**SECOND ADDENDUM TO INITIAL STUDY/
MITIGATED NEGATIVE DECLARATION
(SCH No. 2020059026)**

**SAN MATEO UNION HIGH SCHOOL DISTRICT
MILLS HIGH SCHOOL ATHLETICS COMPLEX PROJECT**

December 2021

Attachment A- Site Plan Showing Previously Approved and Currently Proposed Tree Removal

L01.01
(MHS)

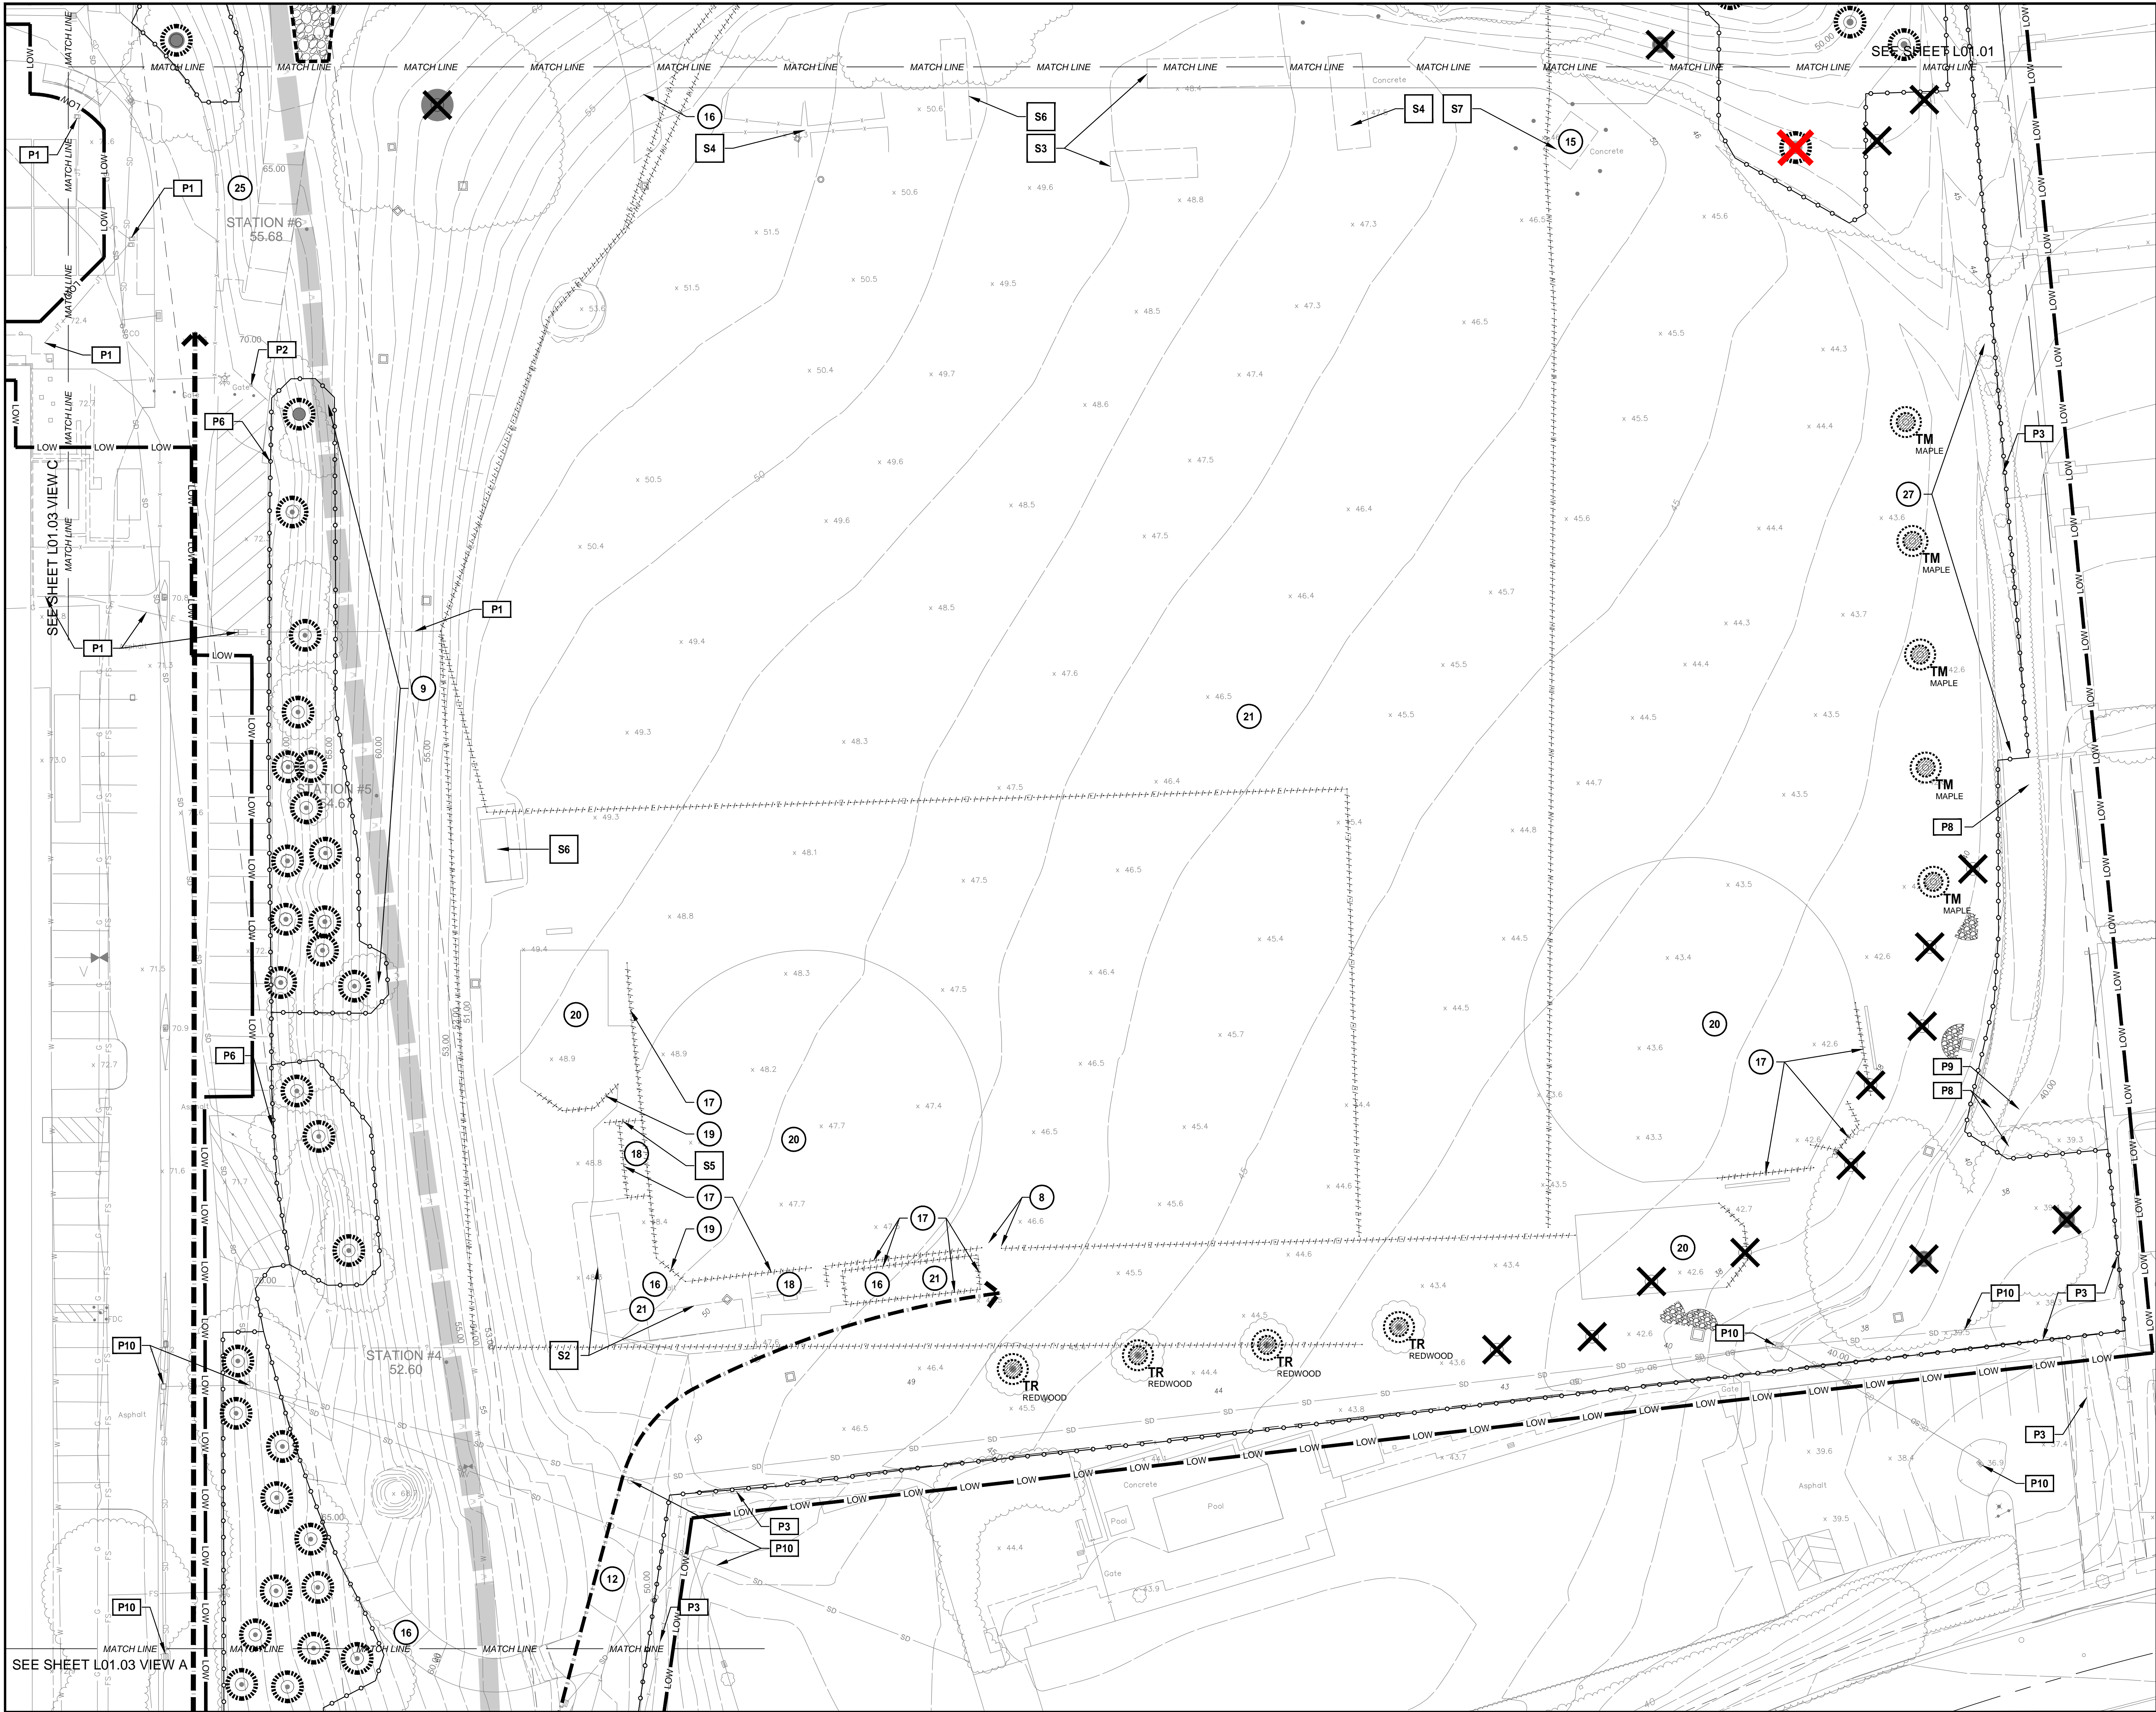
The current project proposes minor adjustments to the site plan described in the IS that would result in the removal of eight additional trees (see Attachment 1 to this Addendum). These include two trees near the project fenceline near Murchison Drive, one additional tree at the edge of the softball field, and five trees at the eastern edge of the tennis courts. The five trees are part of a larger group of trees previously proposed for removal. No other changes to the project would occur.
